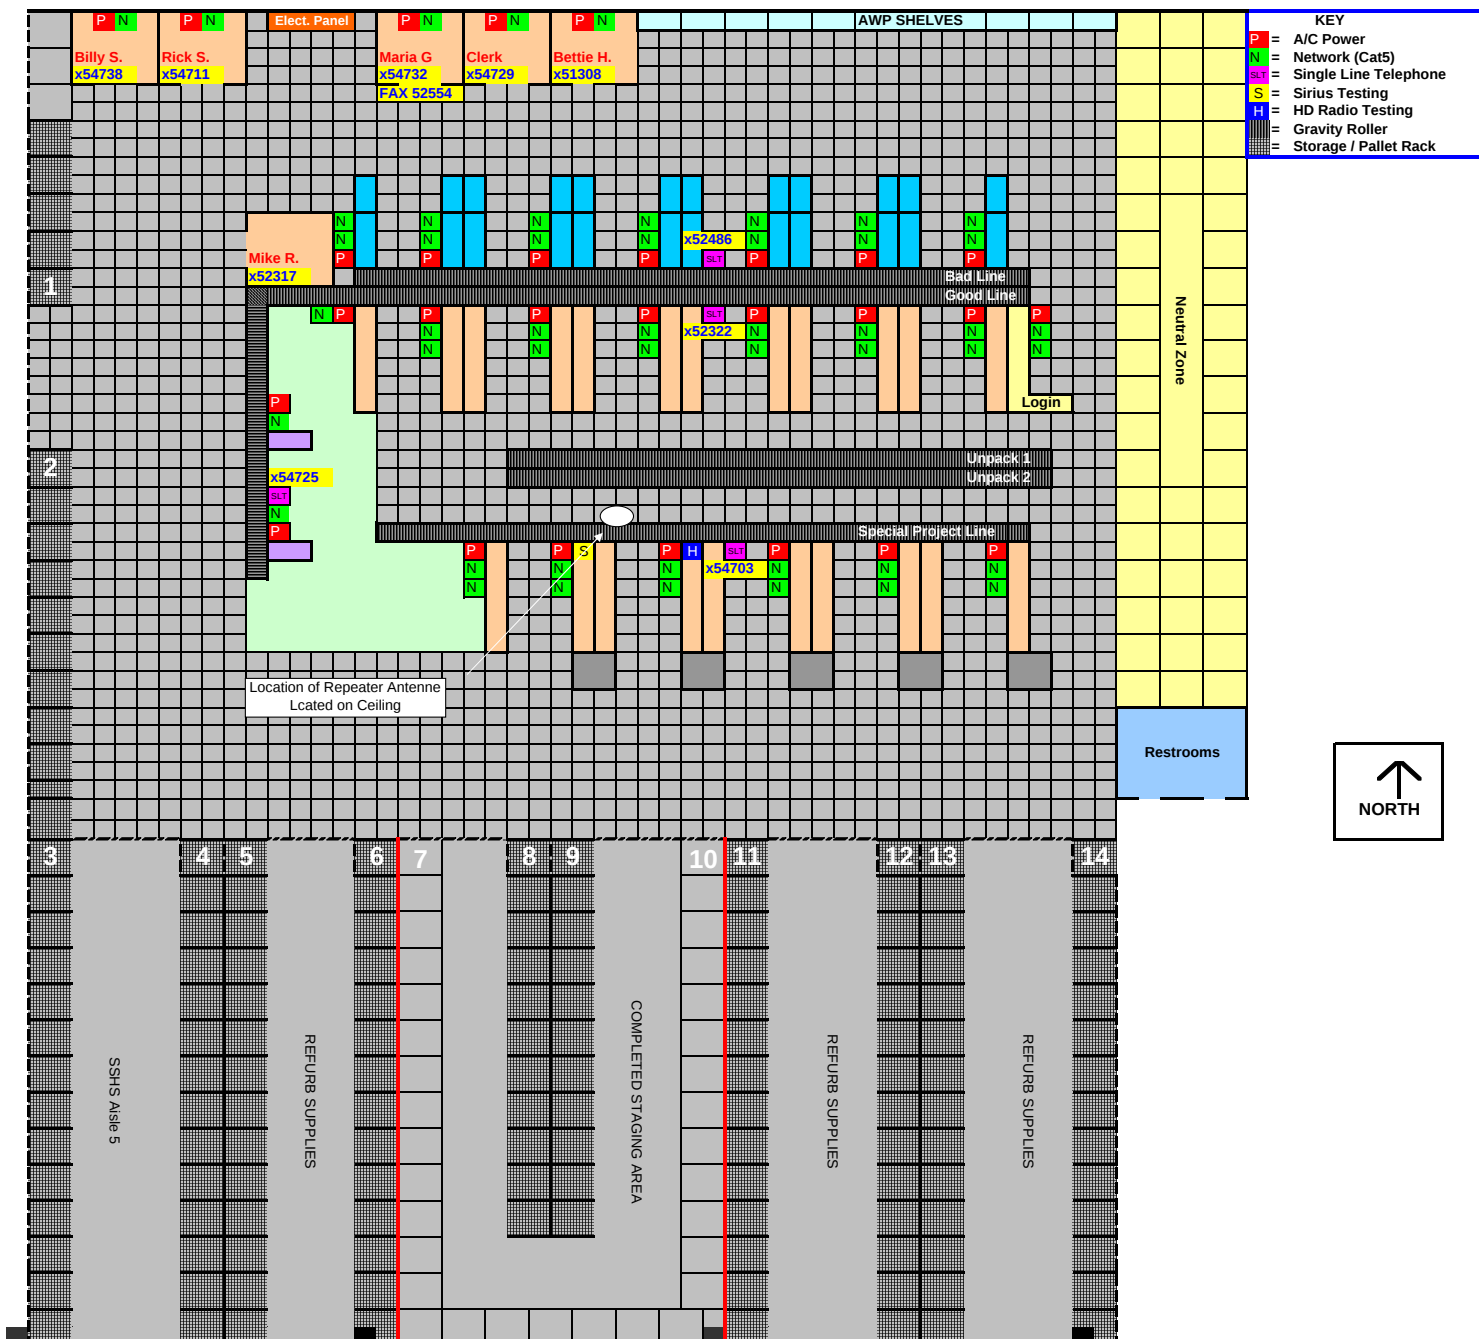
- > Each square on this sheet represents approximately 2 feet.
- > At least 5 additional rows of fluorescent lighting will be needed, in between and matching, the current lighting lengths in the Refrub area. (~90'

- > Additional fluorescent fixtures need to be dropped above the (5) cubicles.
- > The storage racks along the north wall in the Refrub area need to be removed.

- > The northern section of storage rack 1 needs to be removed.
- > Storage racks 2, 3, & 4, can be left in their current configuration.
- > Storage racks 5, 6, 8, 9, 11, 12, 13, & 14, need to be reconfigured for forklift usage.

- > Storage racks 4&5, and 12&13, need to be spaced apart from each other to accomodate standard pallet sizes.
- > Storage racks 7 & 10 need to be removed.

- > Storage racks 8 & 9 need to be shortened to ~44 feet length, and spaced apart to accomodate standard pallet sizes.
- > The red outlined area surrounding the center section of storage racking, indicates a chain link fence.
